ICC A117.1 STANDARD
FOURTH PUBLIC REVIEW DRAFT
BACKGROUND REPORT

ICC/ANSI A117.1 STANDARD
DEVELOPMENT - 2015 EDITION

**ICC A117.1 Standard – Accessible and Usable Buildings and Facilities
Fourth Public Review Draft – Background Report
August 25, 2016**

The following figures were submitted as part of Mr. Gaskins comment.

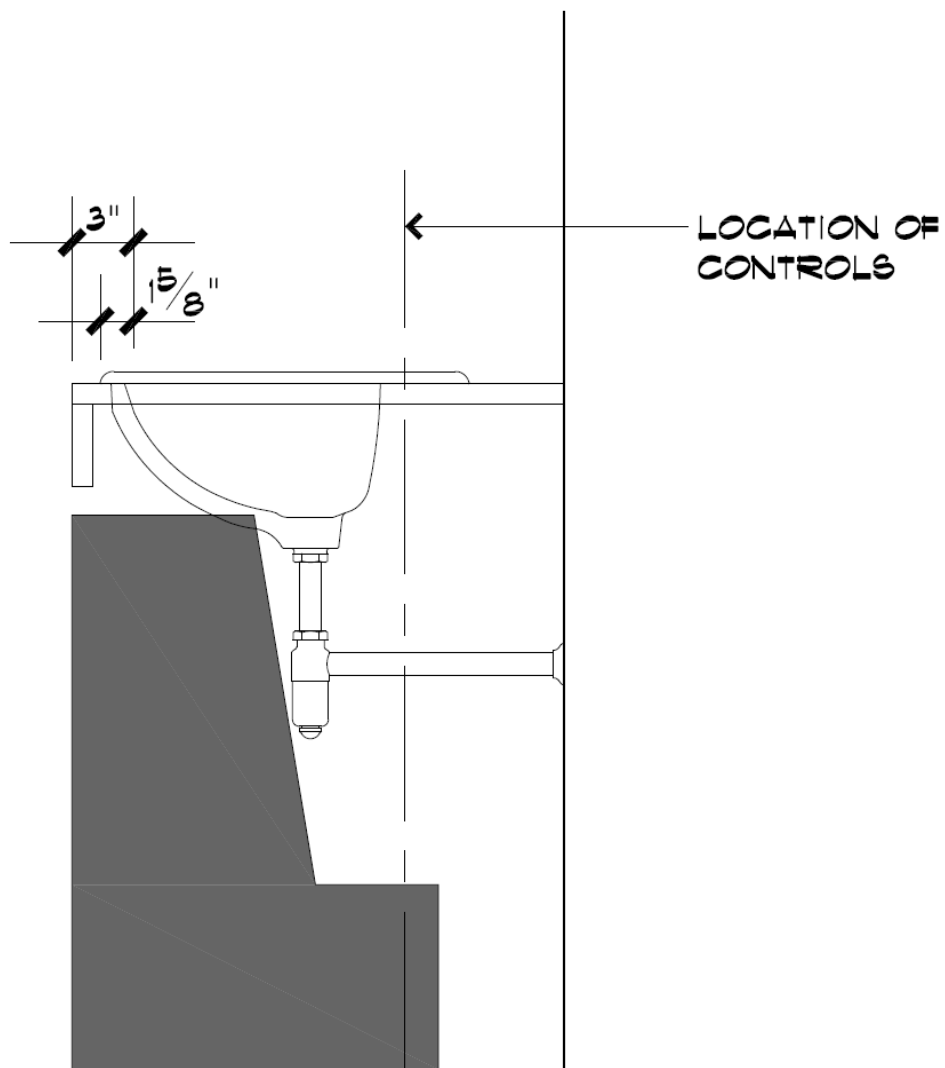
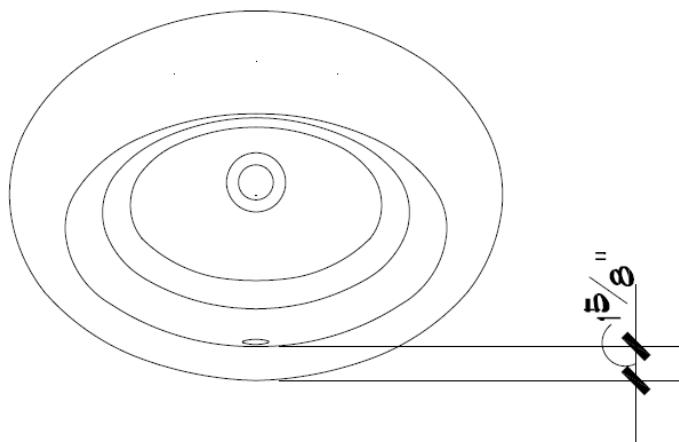
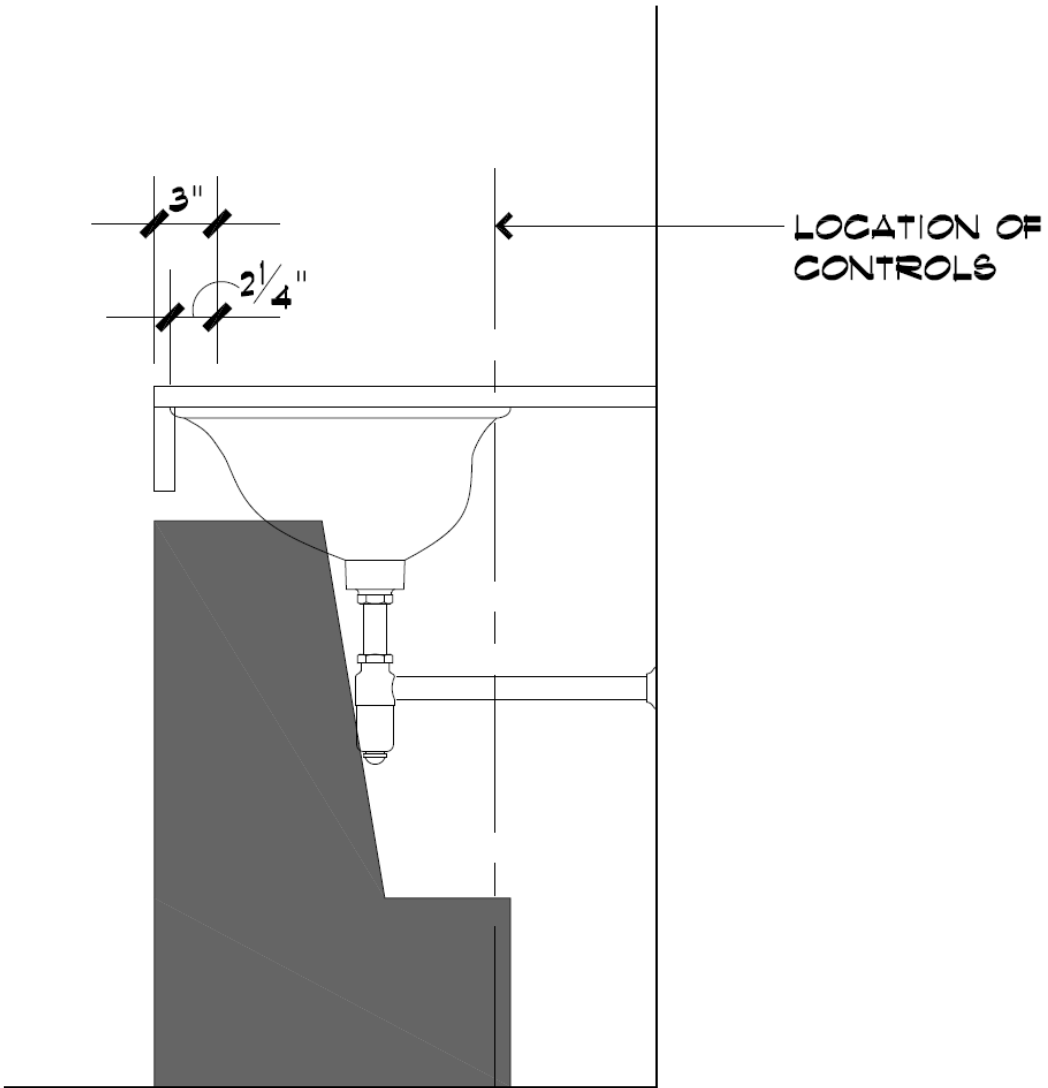
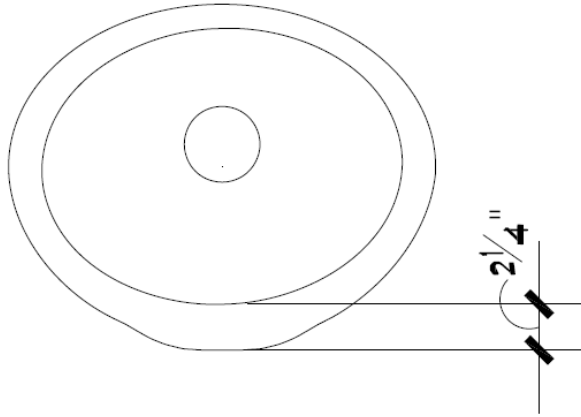
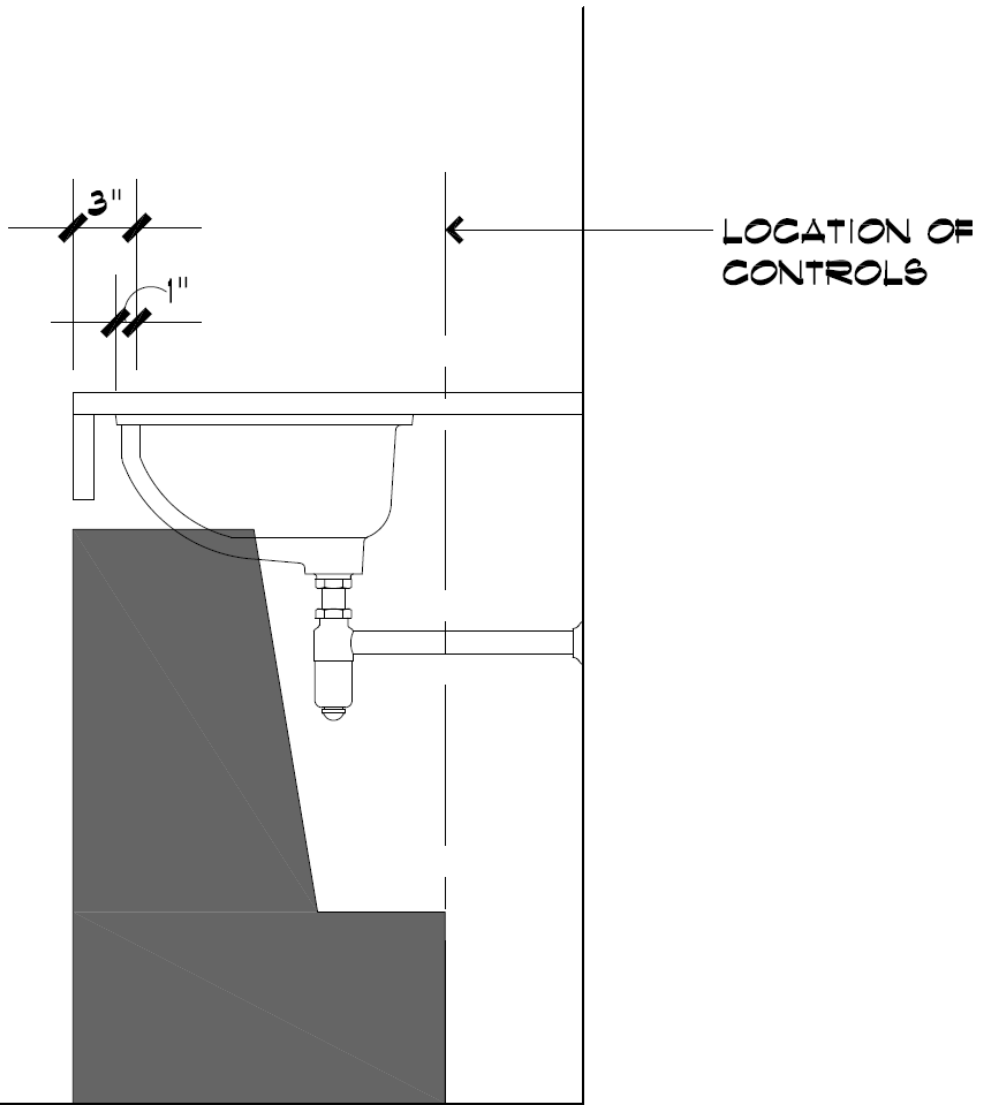
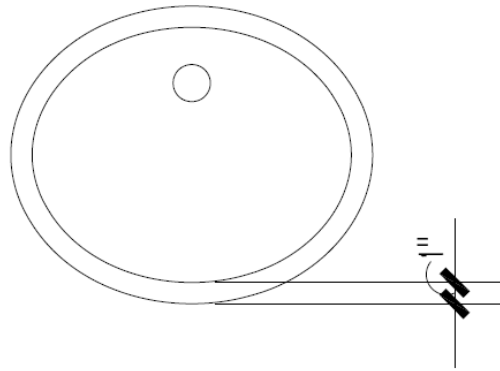
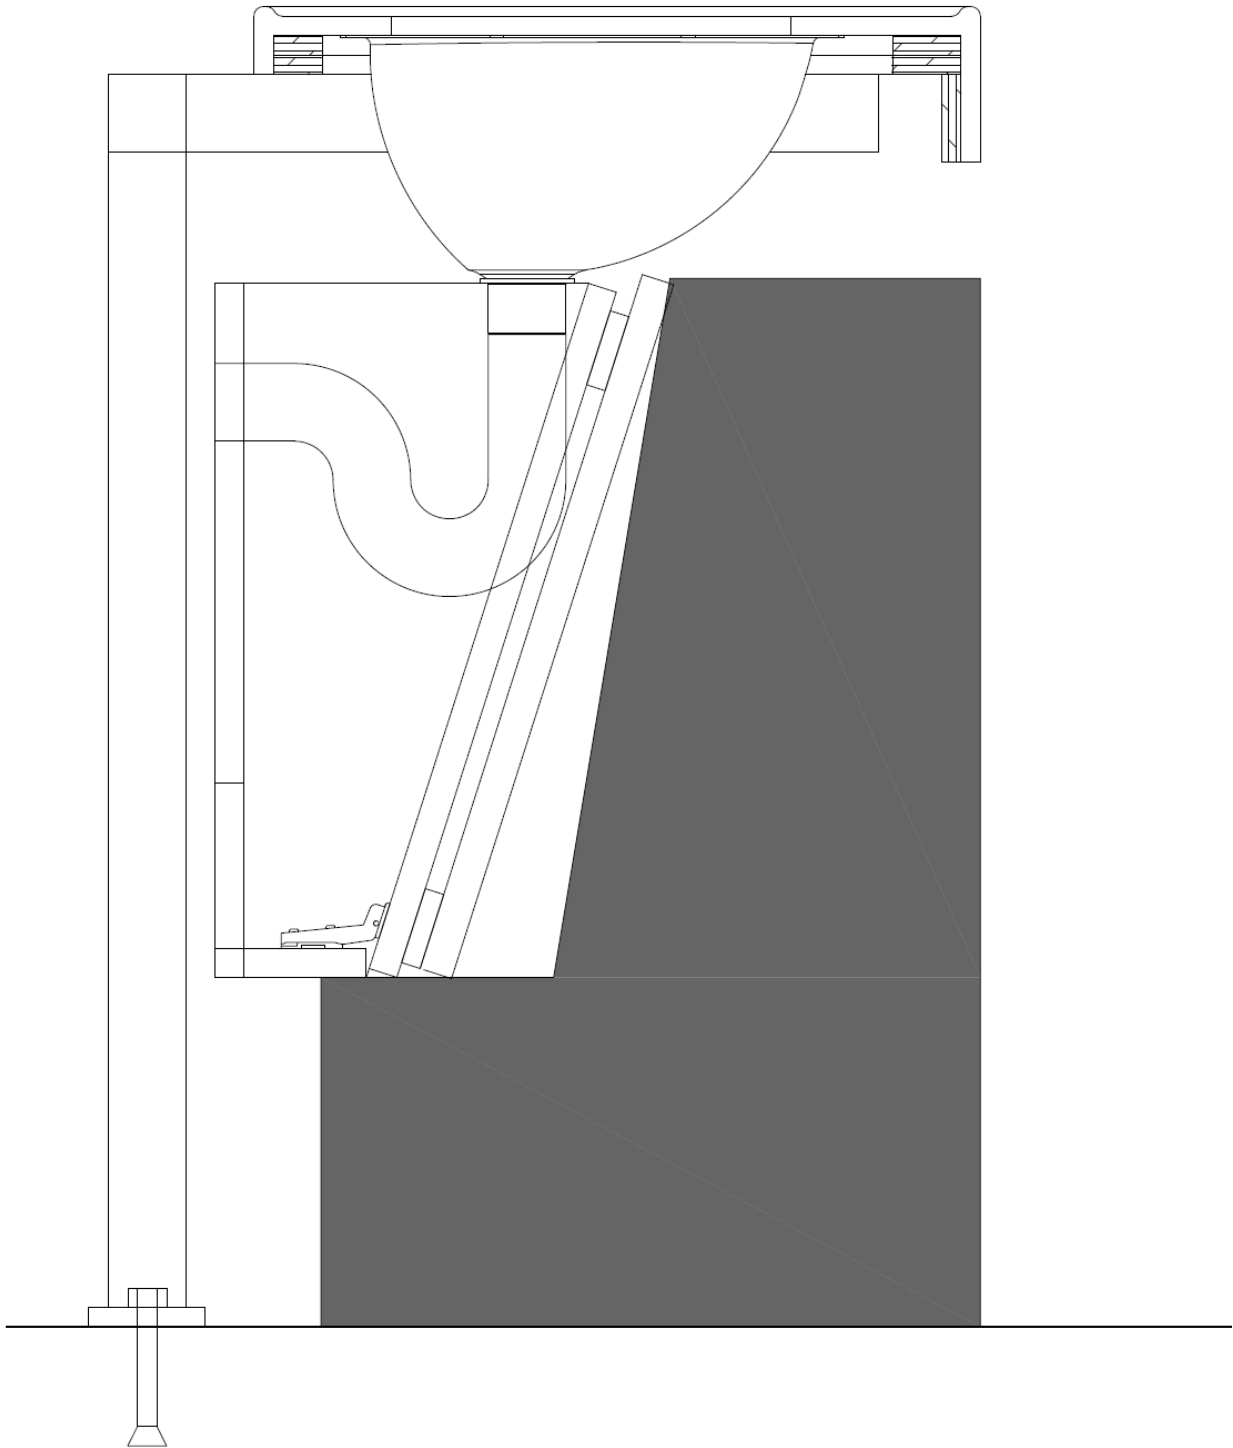
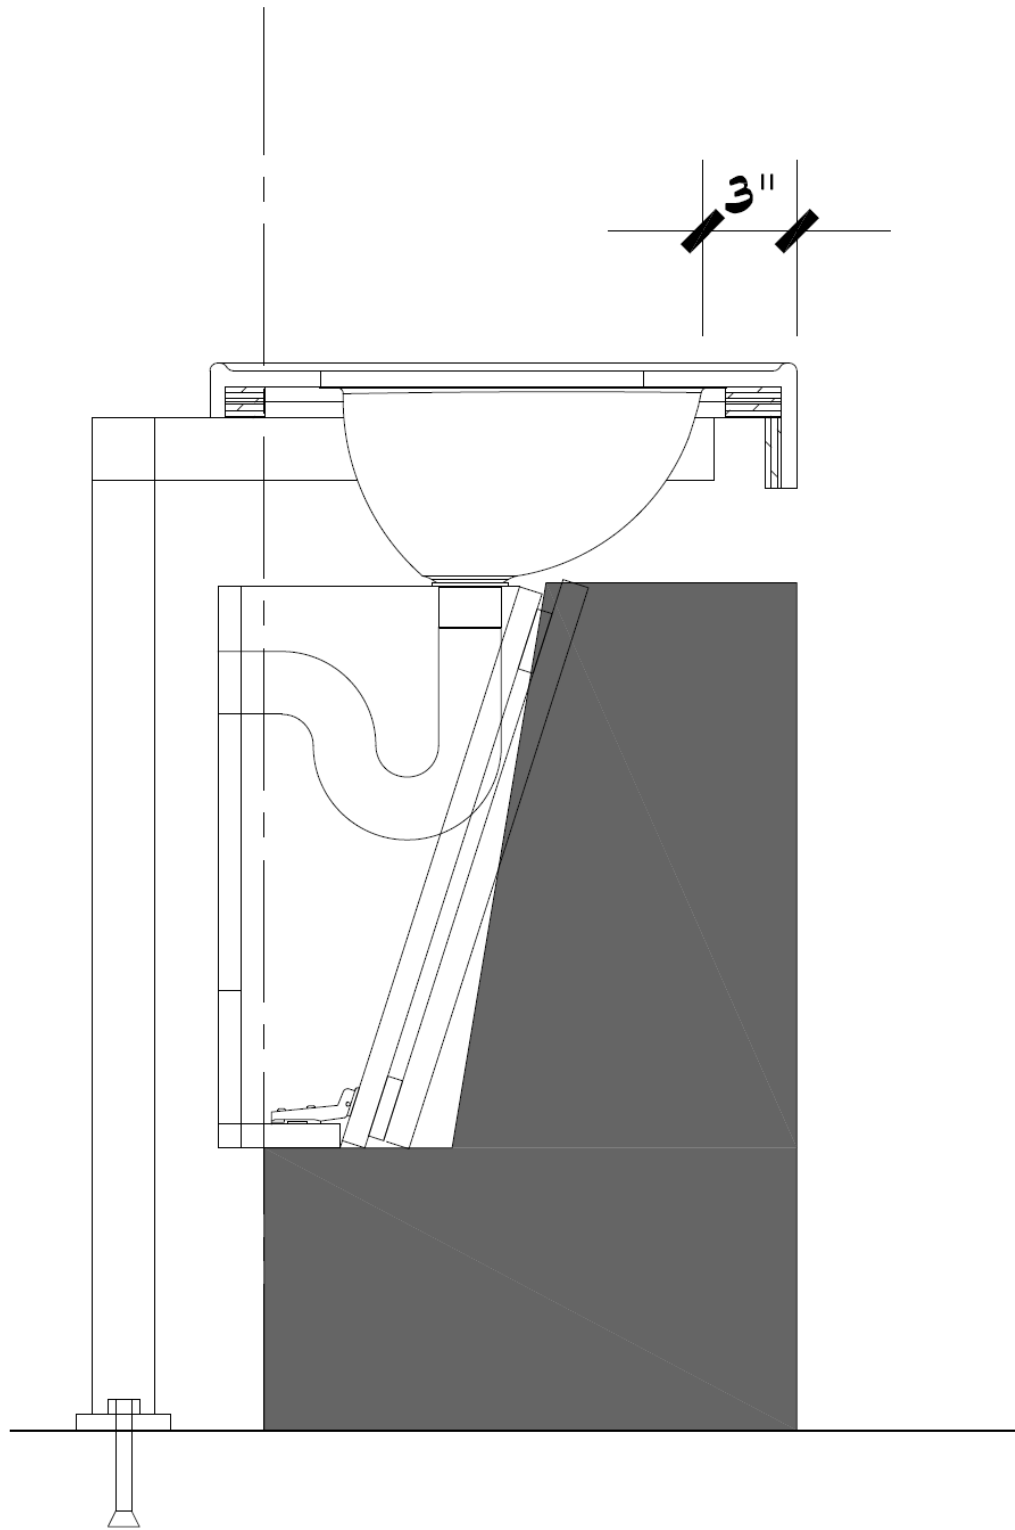
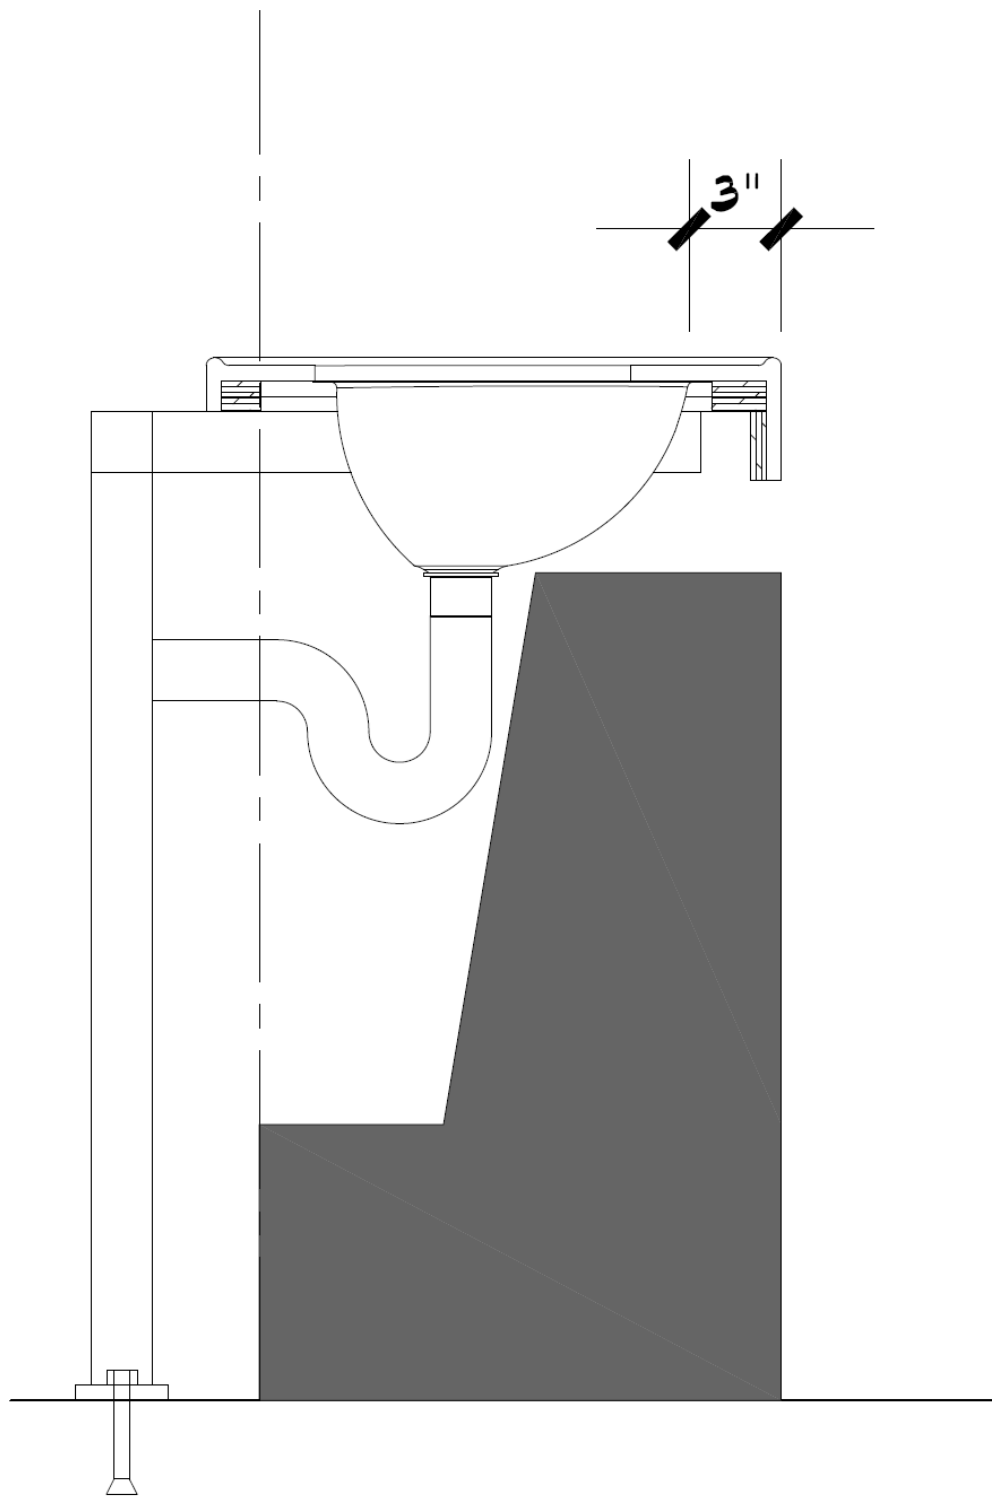
PMI is very much against the original proposal of 3 inches, and this public comment that revises the dimension to 3-1/2 inches for the following reasons:

- The proponents for the 3-1/2 inch maximum lavatory basin setback requirement have failed to provide sufficient evidence to show that setbacks greater than 3-1/2 inches have been an issue in all circumstances. The facts are that a 5 inch setback is necessary to allow the use of various styles of lavatories such as counter-mounted. Additionally, based on the underside contour and style of the lavatory, in conjunction with the countertop thickness, a 5 inch setback is necessary to achieve the required knee and toe clearances.

- As far as providing sufficient evidence for the proposed 5 inch maximum setback, Kohler conducted in-house research that demonstrated that as much as 5 inches was necessary based on some users comfortably stabilizing themselves upon the front edge of the fixture. Additionally, a 5 inch dimension is necessary depending on the style of sink being used as previously indicated. Furthermore, Kohler discovered that a 3-1/2 inch setback was more appropriate for persons with limited reach, and therefore the recommendation by PMI to add the second sentence to Section 606.5.

Interpreter at side of stage

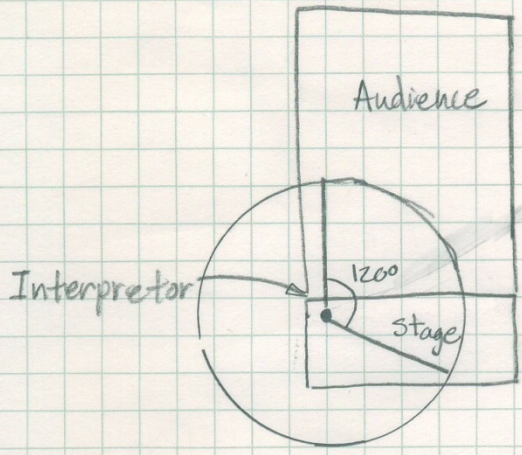
<p>Comment Reason by Kim Paarlberg:</p>	<p>105.2.xx, and 802.11.3 - A handbook that includes recommendations should never be references in a standard that relies on mandatory requirements. This goes against all policies followed by the A117.1 for all other referenced standards.</p> <p>802.11.1 – The phrase “to produce sign language legible from the seating area identified” is replaces by “providing a direct line of sight from”. Whether or not sing language is legible is dependent on the eyesight of the viewer. This language is not clear or uniformly enforceable. The proposed language is consistent with language used in the assembly seating criteria and is more clearly understood.</p> <p>The phrase “and allow periodic interpreter shift changes to take place” is proposed to be struck because this is an operational issue and not clear. Does this mean that there has to be space for two people to exchange, or that there needs to be a place for the 2nd person to stand or sit out of the way? I have seen the 2nd interpreter sit next to the 1st interpreter or come from somewhere else – both options should be permissible.</p> <p>802.11.2 - The word subtend is defined in the dictionary as follows: In geometry, an angle subtended by an arc, line, or other curve is one whose two rays pass through the endpoints of the arc. The precise meaning varies with the context. For example, one may speak of the angle subtended by an arc of a circumference when the angle's vertex is a point on the circumference. A simple theorem of plane geometry states that arcs of equal lengths subtend equal angles in such a situation.</p> <p>Assuming this is the range for where the seats that have a good view of the interpreter are required, if an interpreter</p>

was standing in the middle of the stage, this might be doable. However, the most common place for an interpreter is at the side of the stage. This literally would require the viewing area to be behind them. See Figures. The maximum” could be read to indicate that the angle could be anything up to that range in width – including 0 degrees – which I don’t think was the intent. ‘Unobstructed’ to 65 feet could be interpreted to not allow any columns in the room in that area. Thus the room we have our A117.1 meetings in would be in violation. Since an interpreter could be of any height, using the size of the interpreter for the viewing range is not consistent.

The intent of the revisions to the last sentence is intended to provide more precise information of measurement. However, this requirement should probably be deleted because it could prohibit seating immediately in front of the interpreter when the interpreter is on any type of raised platform or stage.

Please see Comment Reason provided by Ms. Paarlberg. The committee approved this public comment as a welcome improvement and refinement of these provisions which will be new to the A117.1 standard.
